BULLETIN #204C

W41/W55/W56

MODIFICATION TO W41-12 PCB

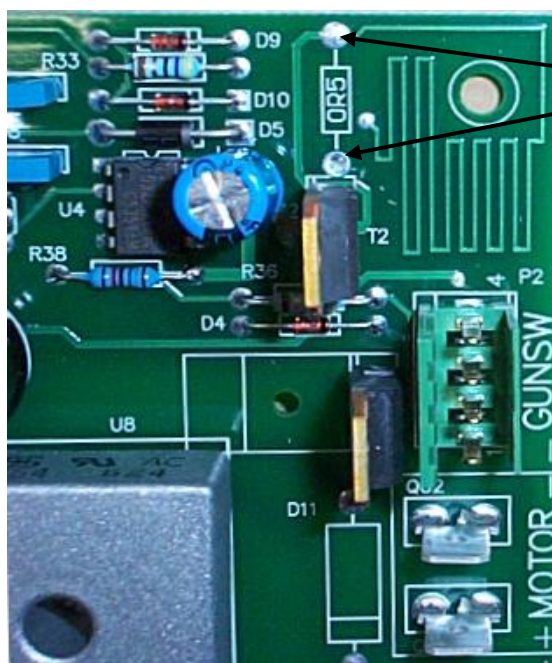
There have been some failures of the W41-12, (Issue E) pcb in the field, especially when frequent starts are made. The brake resistor may become so hot that it fails, causing failure of the motor drive mosfet and driver chip, thus disabling motor drive. The following modification shows how to take the brake resistor out of circuit. Factory testing has now demonstrated that the circuit is more robust without the brake resistor.

Join these two spots with a jumper wire.

1. Isolate the power to the welder.
2. Remove the covers from the wirefeeder.
3. Unplug the connectors from the wirefeed pcb, carefully noting where each connector goes.
4. Remove the wirefeed pcb.
5. Carefully solder a jumper wire into the position shown. The wire lead from a spare resistor would make a suitable jumper wire.
6. Refit wirefeed pcb and test operation.
